SUBJECT: Muffler Caps with Shield

DATE: 1/72

SUBJECT: Guide Bar Adjusting Pin

There is a possibility that the guide bar adjusting pin in the drivecase cover may be assembled up-side down. The diagram below shows an inside view of the drivecase cover showing the adjusting pin in the correct position.

Guide bar adjusting pin
in the correct position

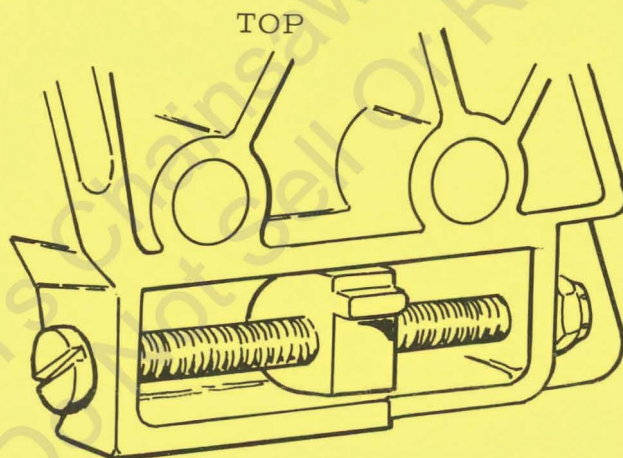
Note that the adjusting pin is assembled with the engaging pin above the center line of the adjusting screw.

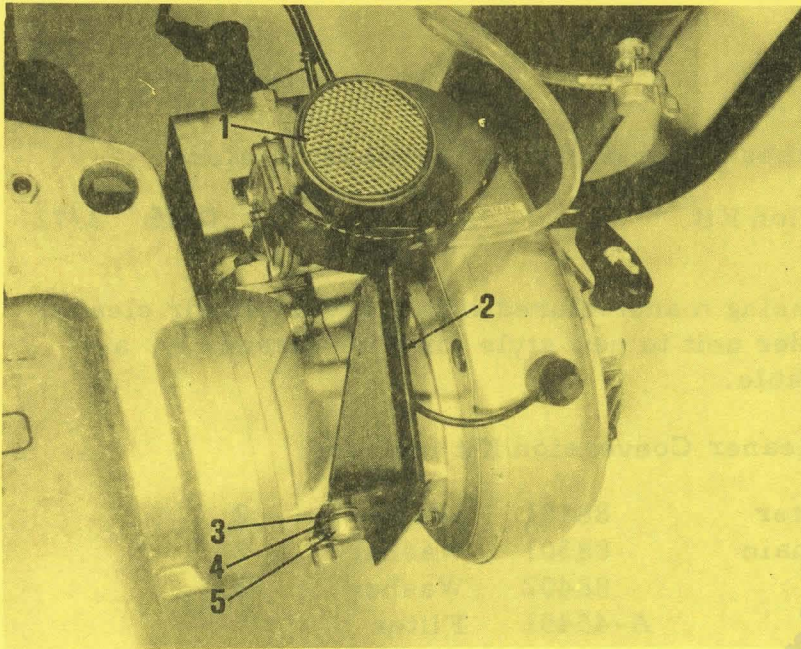
If new style carburetor used with old style air filter system main carburetor jet #45386 must be installed.

Only difference between new and old carburetor is the main jet.

If old style carburetor used with new style air filter system, main carburetor jet #45448 must be installed.

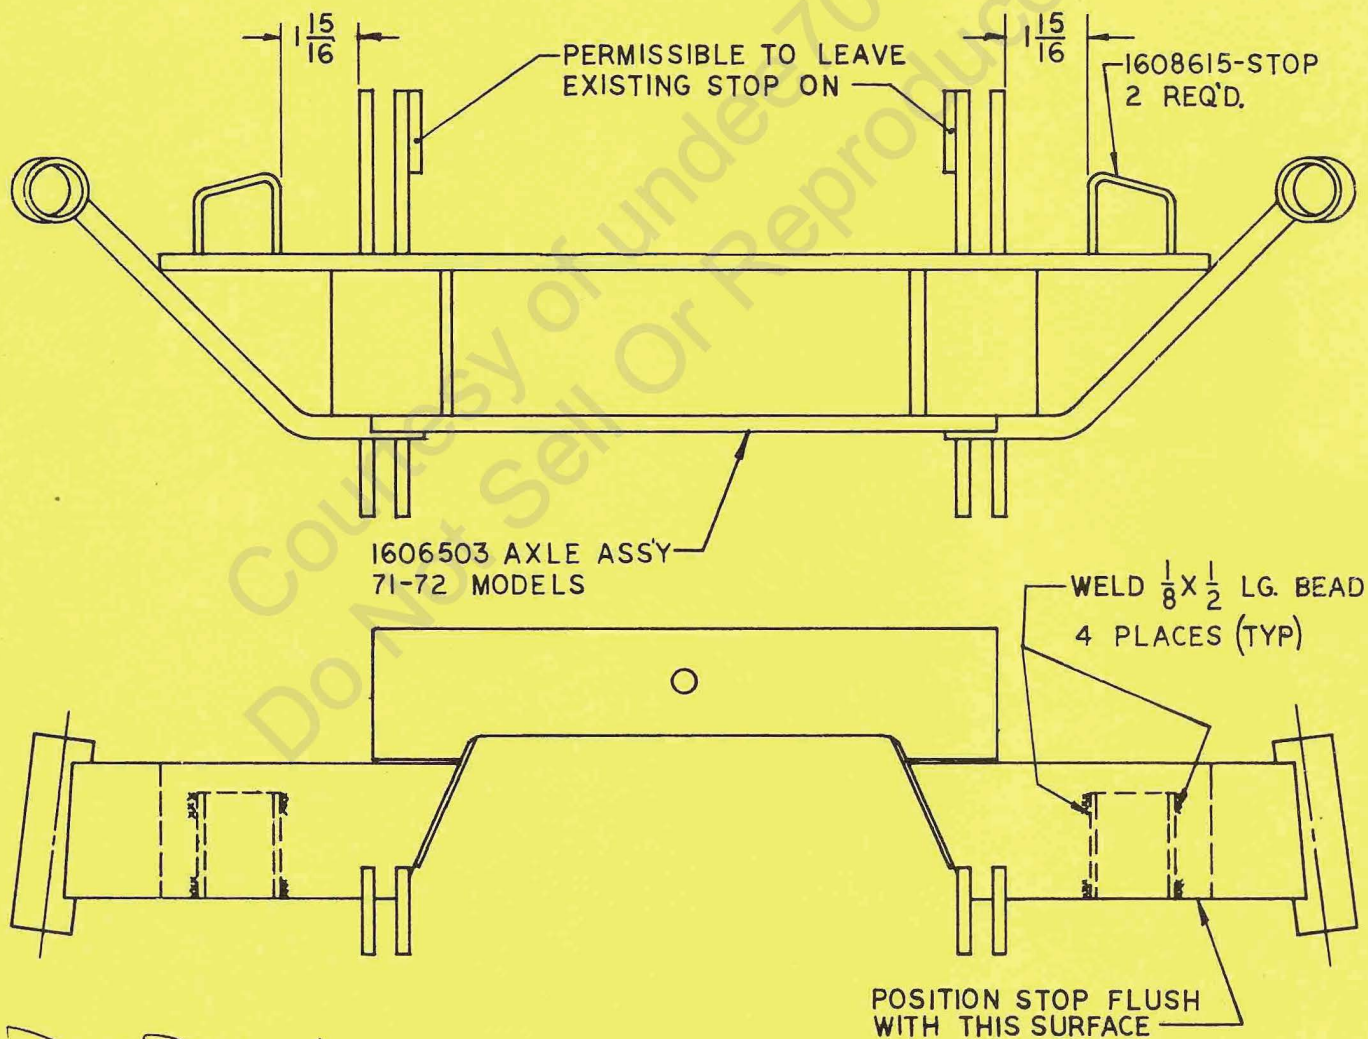
Occasionally we have tractors in the field where oversteering will cause the front spindle to ride past its stop. This possibility has been eliminated in the 1973 models by the addition of new stops. These two new stops #LM-16086-15 are available for the 1972 tractors with this steering condition. The illustration shows the welding location on front axle assembly #LM-16065-03.

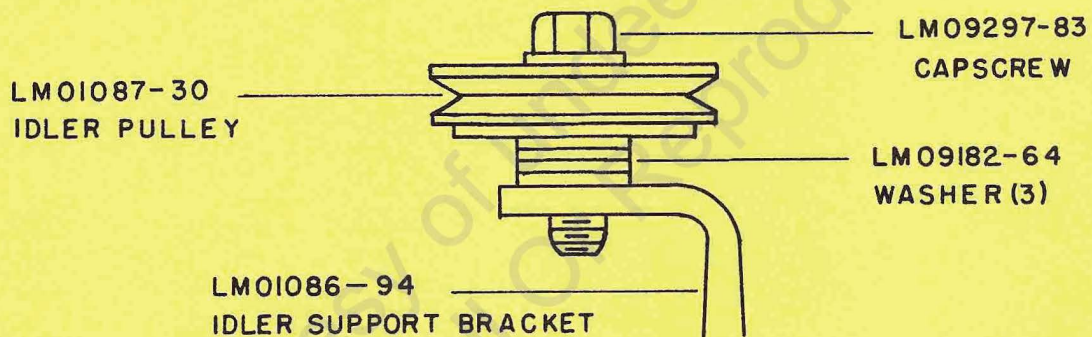
The belt on M-21S mower can jump off the idler pulley LM-01087-30 if engine "back fires" in starting or stopping. When the idler pulley is raised $3/16$ " , the exit angle of the belt is reduced enough to hold the belt if engine happens to "back fire". To raise the idler pulley $3/16$ " use one cap screw LM-09297-83 and three washers LM-09182-64.
